DONHAM PLACE SUBDIVISION, UNIT TWO

APPLICATION NUMBER 13 DATE August 7, 2003

REQUEST Subdivision

DETAIL SITE PLAN

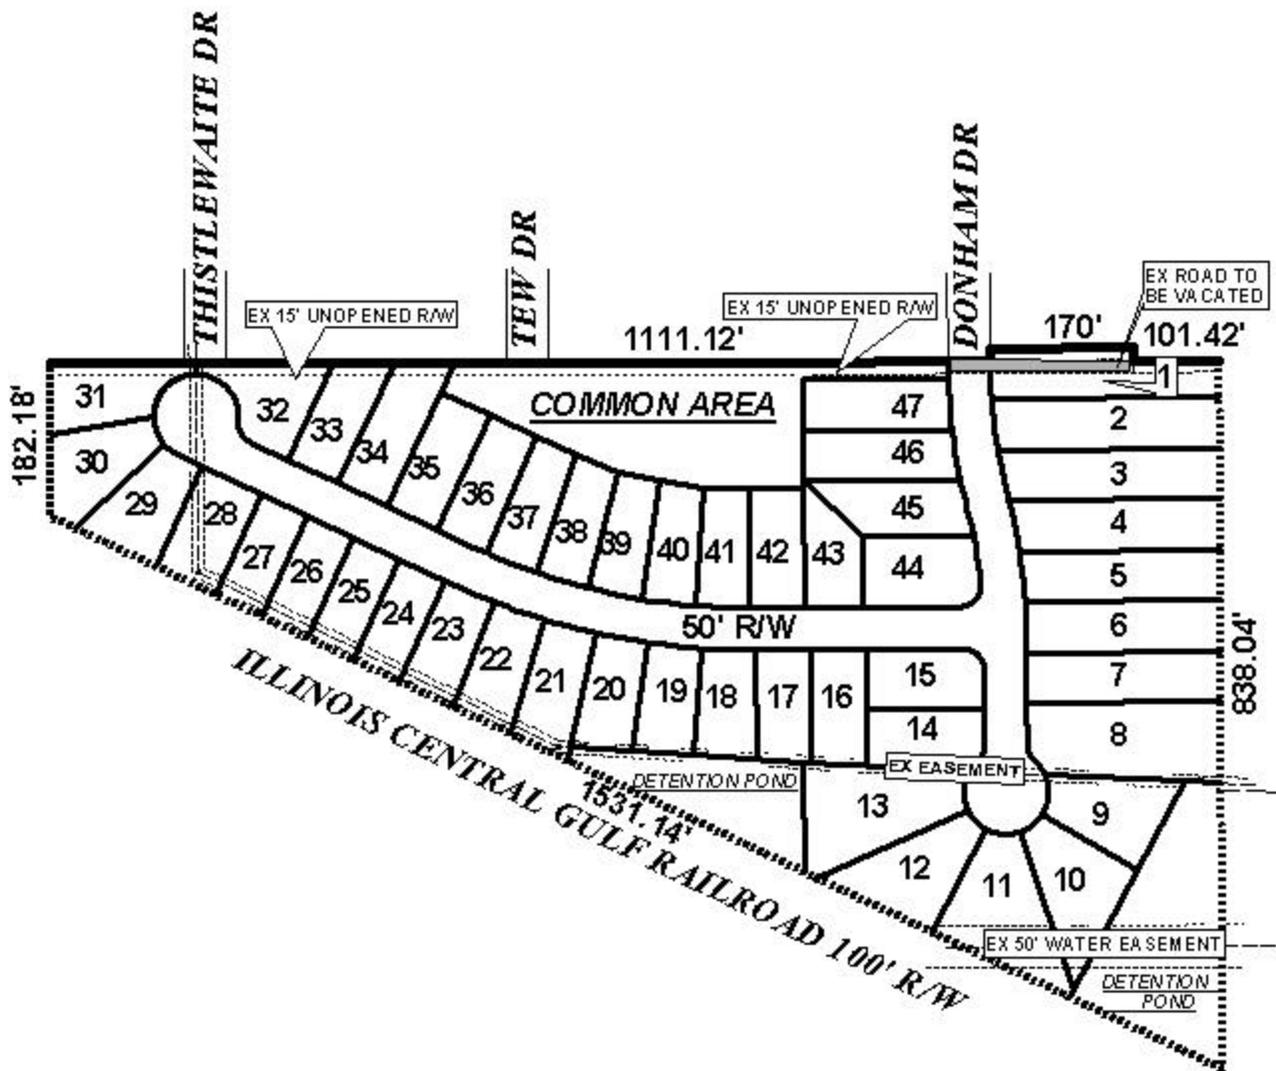
The site fronts Middle Ring Road, a planned major street and has right-of-way in compliance with the Major Street Plan. As a means of access management (once Middle Ring Road is constructed), a note should be placed on the final plat stating that Lots 30 and 31 are denied direct access to Middle Ring Road.

As illustrated on the site plan, there is 15-foot road that the applicant proposes to vacate; this right-of-way should be vacated prior to the recording of the final plat. It should be noted that the road was not illustrated on the previous approval and thus was not a condition.

As illustrated on the site plan, there are two proposed detention ponds and a common area. The use of all common areas should be noted on the final plat with a note stating the maintenance thereof shall be the responsibility of the property owners. Additionally, access for the maintenance of these commons areas would also be required.

As proposed, Lots 1 through 8 would exceed the width to depth ratio, therefore a waiver of Section V.D.3. would be required.

With a waiver of Section V.D.3., the plat meets the minimum requirements of the Subdivision Regulations and is recommended for Tentative Approval subject to the following conditions: 1) the placement of a note on the final plat stating that Lots 30 and 31 are denied direct access to Middle Ring Road; 2) the vacation of the 15-foot right-of-way prior to the recording of the final plat; 3) the placement of a note on the final plat stating that the maintenance of the common areas shall be the responsibility of the property owners; and 4) the provision of access to the common areas.
